**Response to Data Requests  
1 through 97**

**Application for Certification**  
for the

**Walnut Creek Energy Park**

City of Industry, California  
(05-AFC-02)

**FIGURE DR75-1**  
**ALTERNATIVE ACCESS ROUTES**  
 WALNUT CREEK ENERGY PARK  
 CITY OF INDUSTRY, CALIFORNIA  
**CH2MHILL**

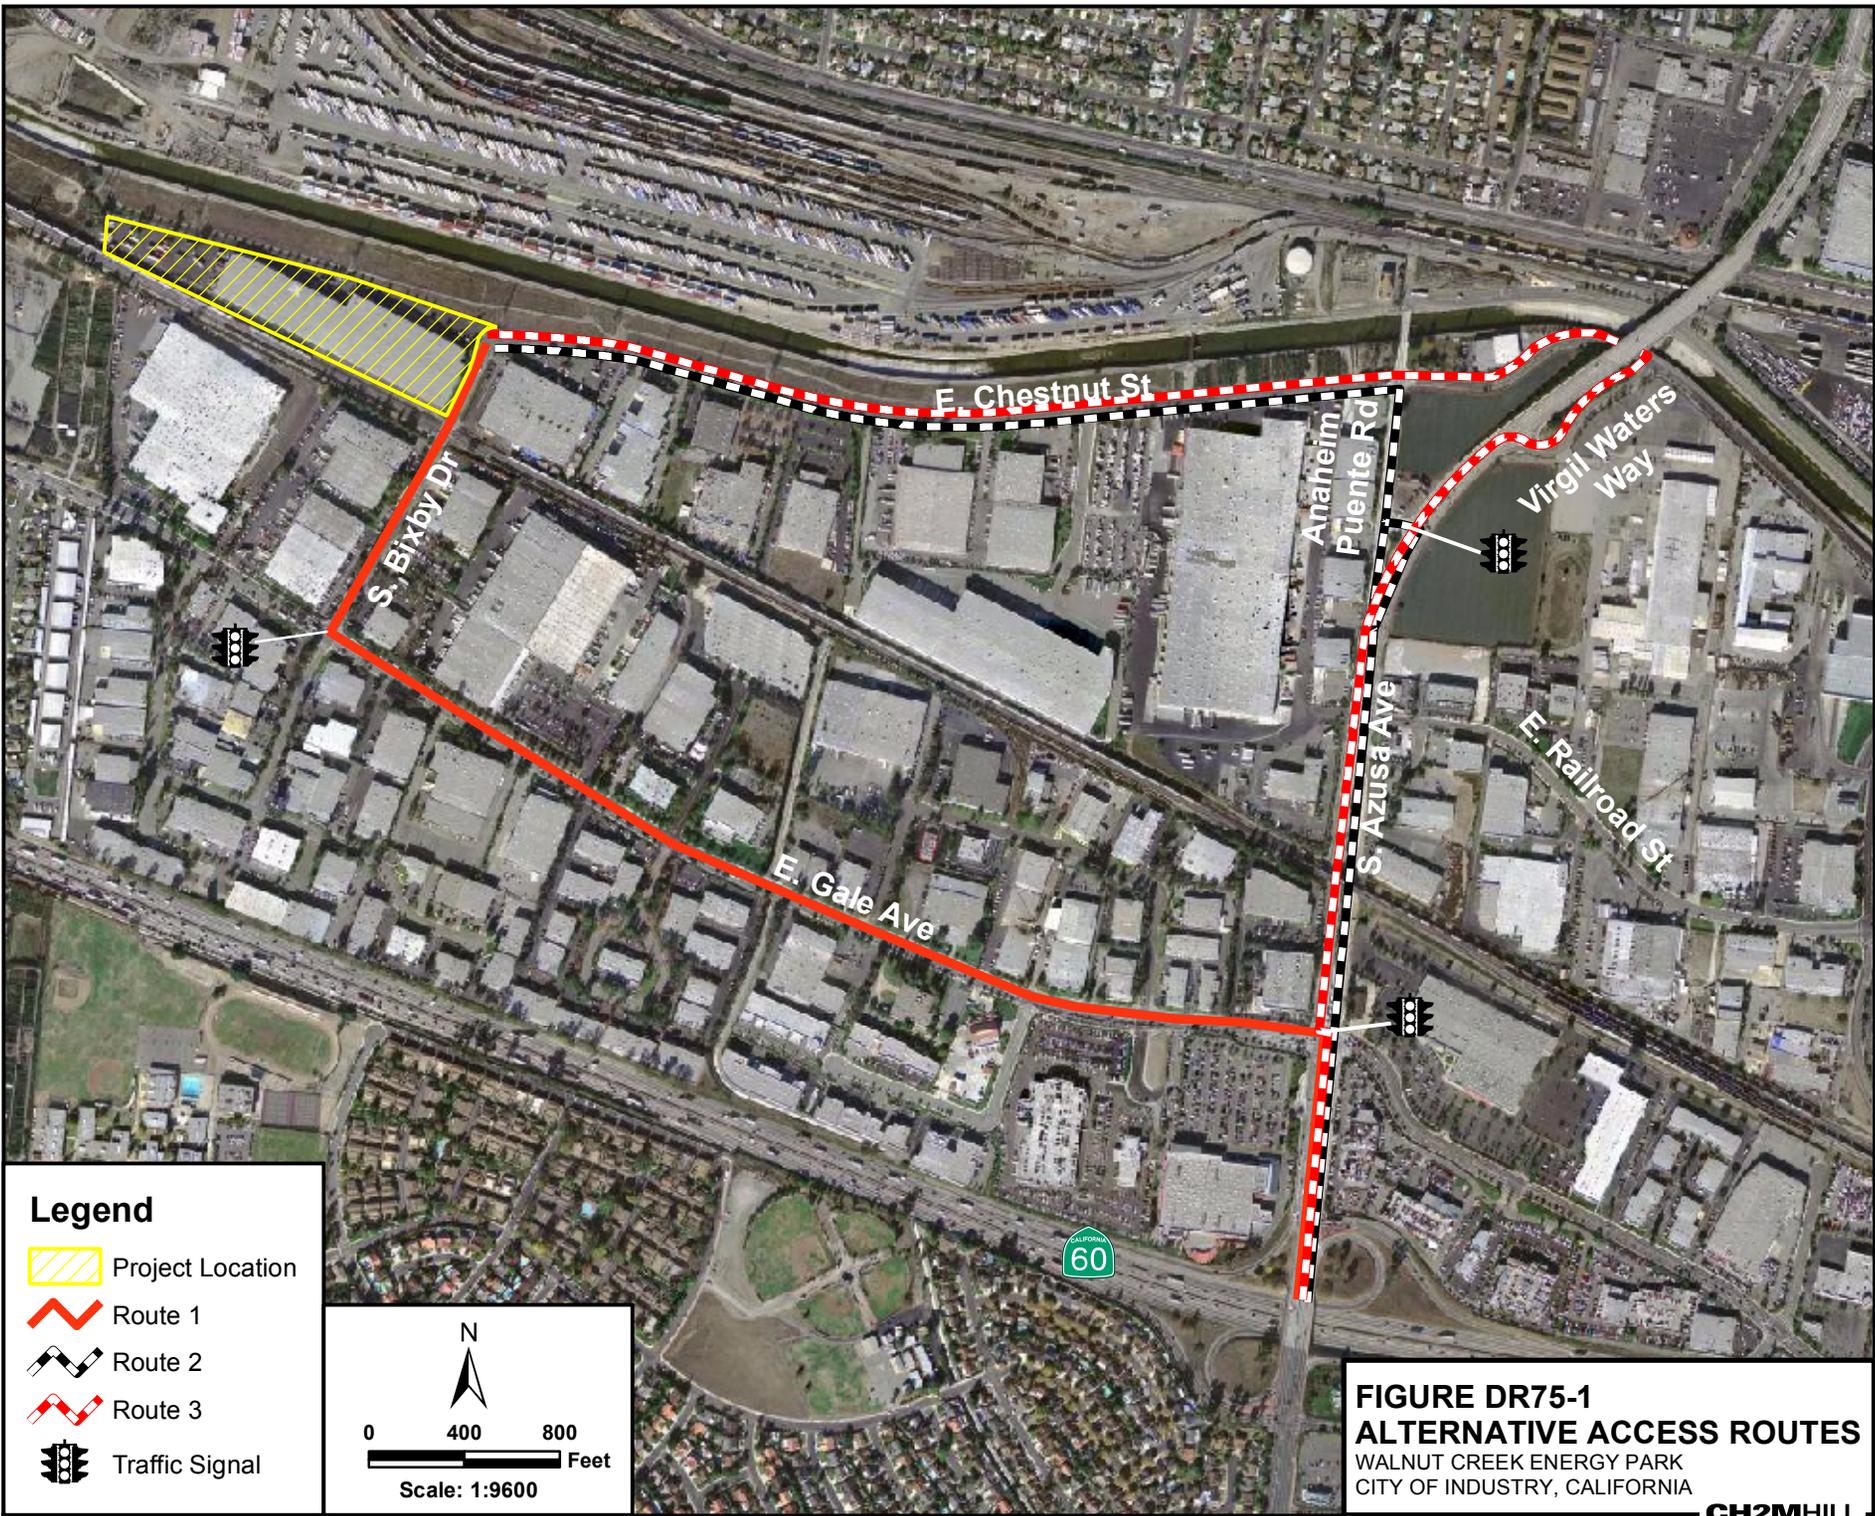
**Route 3:** Travel north on South Azusa Avenue; northeast onto Virgil Waters Way; and west on East Chestnut Street to the project site.

Inbound traffic on this route makes a right turn merge at the South Azusa Avenue/Virgil Waters Way intersection onto Virgil Waters, a left turn at the Virgil Waters Way/East Chestnut Street intersection to East Chestnut Street, and a right turn into project site.

**FIGURE DR87-1  
PLUME SOURCES WITHIN 1 MILE  
OF PROJECT SITE**

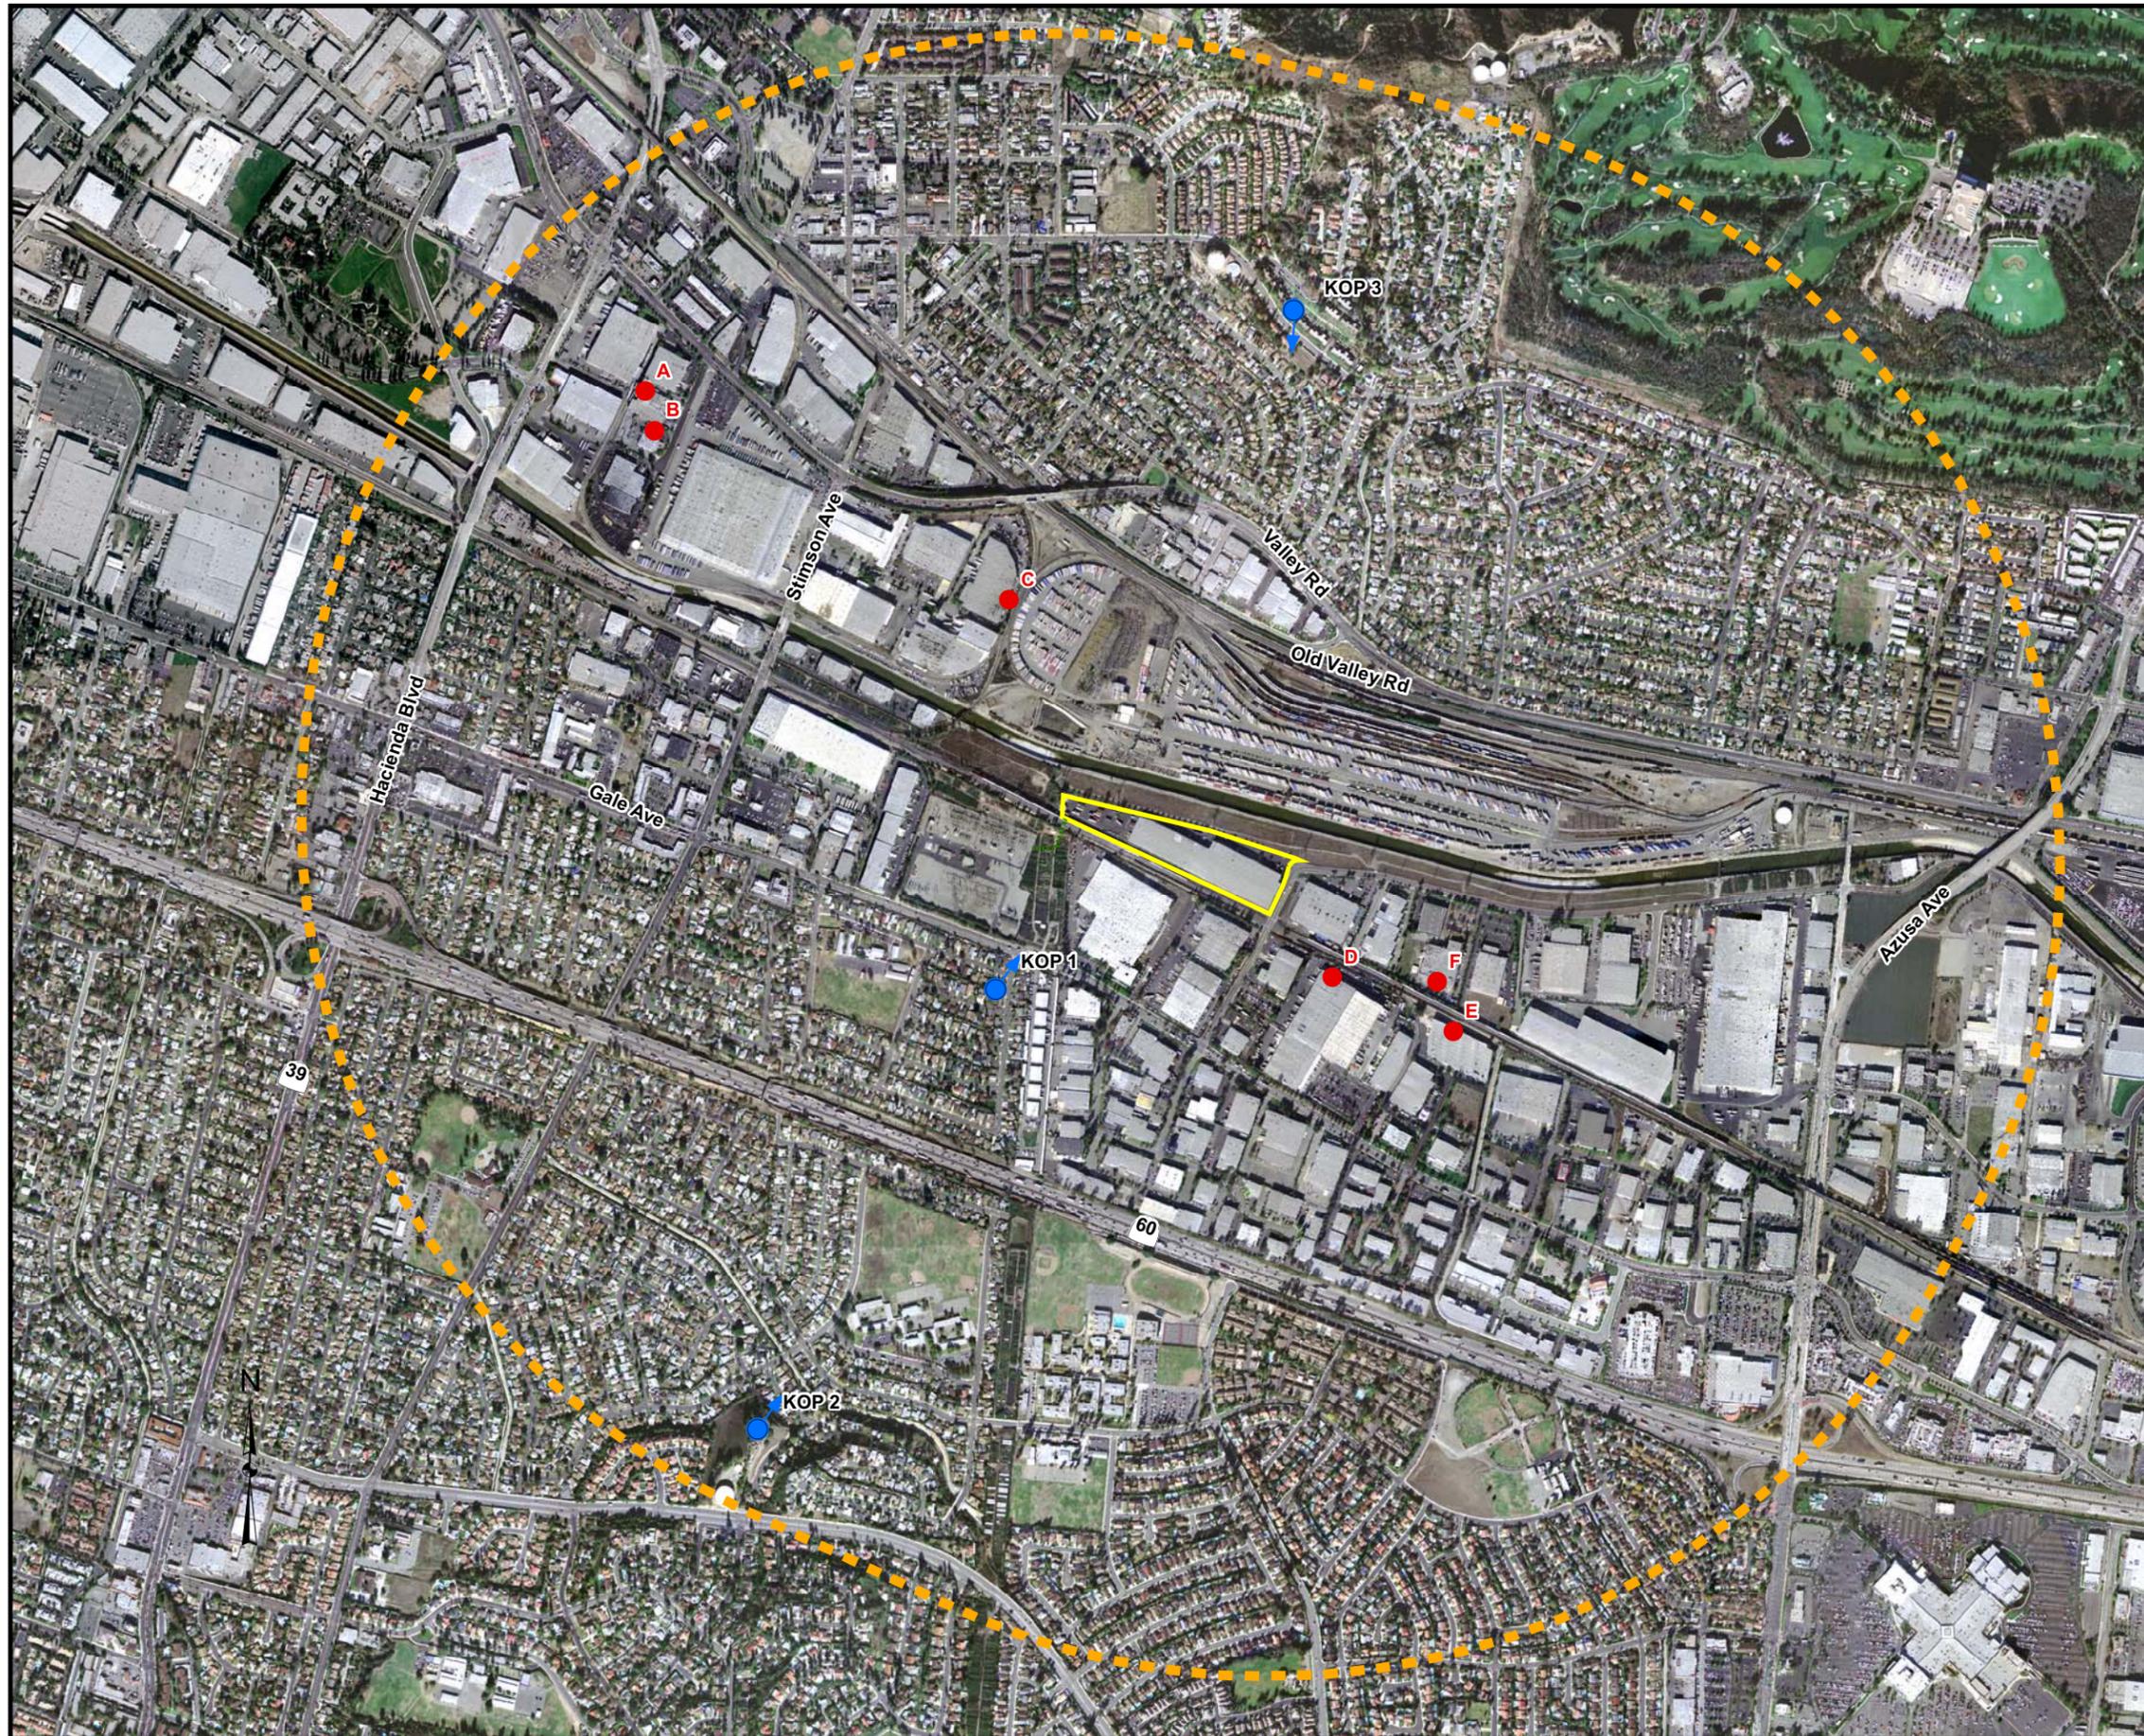
The observations revealed that although plumes exist within the portion of the industrial corridor within one mile of the proposed project site, there are relatively few of them and that in general, they are not large. The plumes and potential plume sources identified in the area within one mile of the project site are described below, and their locations are marked on the air photo presented as Figure DR87-1. All of the addresses noted are located within the City of Industry.

The largest plume visible in the area within one mile of the project site is the steam plume that emanates from one of two stacks located at Nutro Products, a manufacturer of premium dog and cat foods, at 445 South Wilson Way. This facility is located 0.75 mile to the northwest of the project site. Figure DR87-2A is a view of this plume as it appears in the early morning as seen from KOP-1 overlooking the valley in which the City of Industry is located. Figure DR87-2B is a view of this plume as it is seen from Wilson Way in front of the Nutro Products facility.

Semco Enterprises, located at 475 South Wilson Way, next door to Nutro Products and 0.75 mile to the northwest of the project site, is a zinc alloy die casting facility. As review of Figure DR87-2B indicates, this facility has four short stacks. On the morning that observations were made, a small, faint black plume was emanating from one of the stacks.

Langer Juice Company, located at 16195 Stephens Street, 0.25 mile to the northwest of the project site is a large juice production and distribution facility with a set of vents on its roof that is the source of a small number of small steam plumes. These plumes are visible in Figure DR87-3B, a view toward the southwest from KOP-1.
